Staff Report & Recommendation

Design Review Board

SUBJECT: DRB19-0396
1570 Alton Road "TD Bank"

DRB19-0396, 1570 Alton Road. An application has been filed requesting Design Review Approval for exterior alterations to an existing one-story building including new signage and modifications to the façade and a variance to exceed the maximum sign area for projecting signs.

Original building permit elevation drawings, DRB8080

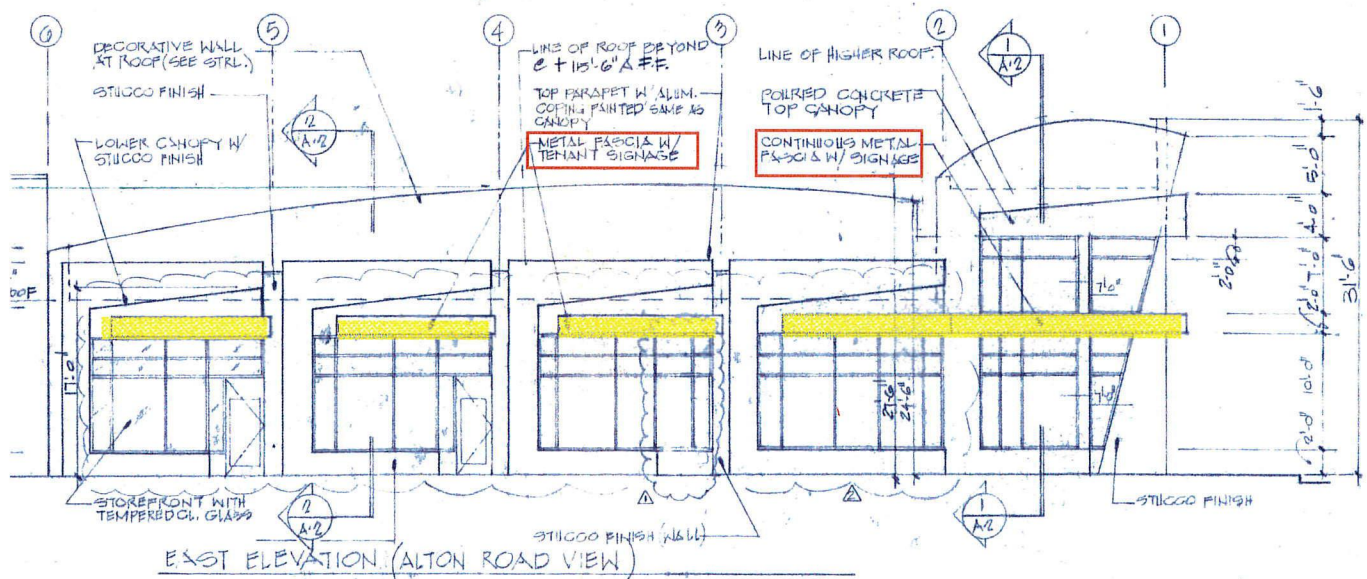
Staff's primary concerns with the application still pertains to the awkward three-sided sign cube proposed to be suspended within the lower and upper canopies of the corner entrance. Staff has offered to work with the applicant to find alternate location that would be compliant with the sign code and more compatible with the existing structure.

From the 1996 staff report for DRB 8080,

"The elevations are highly contemporary in scope with each individual storefront incorporating decorative fin projections; the corner of the building is highlighted by upper and lower canopies. At the roof of the structure, a larger fin wall, which commences at the south side of the structure and spans the entire width of the building along Alton Road, gently rises in height and reaches a crescendo at the corner."

"Signs on the metal fascia may only be 15 s.f. (projecting sign)"

This clearly illustrates that the design intent of the metal fascia was to act as a sign band in order to provide uniformity to the contemporary commercial structure with the potential to contain multiple tenants.

Staff recommends that the box sign be eliminated altogether, and that the main signage be redesigned as a single row of individual, reverse channel character letters with a brushed aluminum finish that can each be backlit along the metal fascia eyebrow element. Furthermore, the location of both the signs and the proposed fascia replacement may be outside the property lines and, if so, would require a revocable permit from the City Commission and an approval from the Public Works Department.
